CMA PRODUCT IMPROVEMENT

Effective Date: MAY 2015
Log Number: CMA-PI-462
Subject: EST-44/66 WASH MANIFOLD
Models Affected: EST-44, EST-66

EST-44/66 WASH MANIFOLD

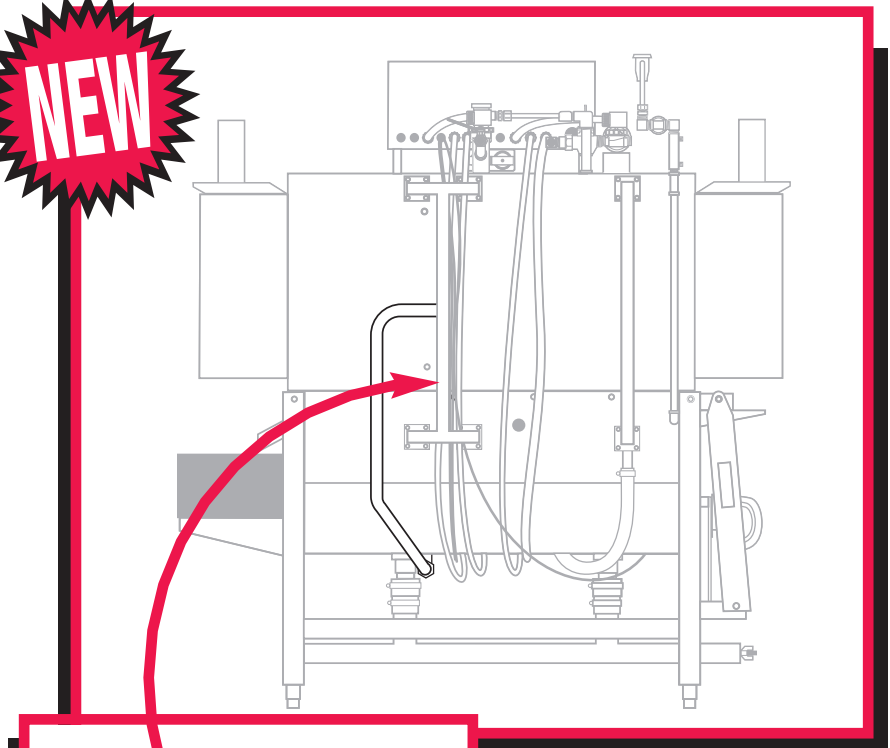
The newly engineered “Wash Manifold” improves the flow rate to the upper and lower wash arms. The Stainless Steel pump discharge line centered on the Dual Wash Manifold provides a better balanced flow rate to the Wash Arms, which inturn provides a more consistant spray pattern over the dishes.
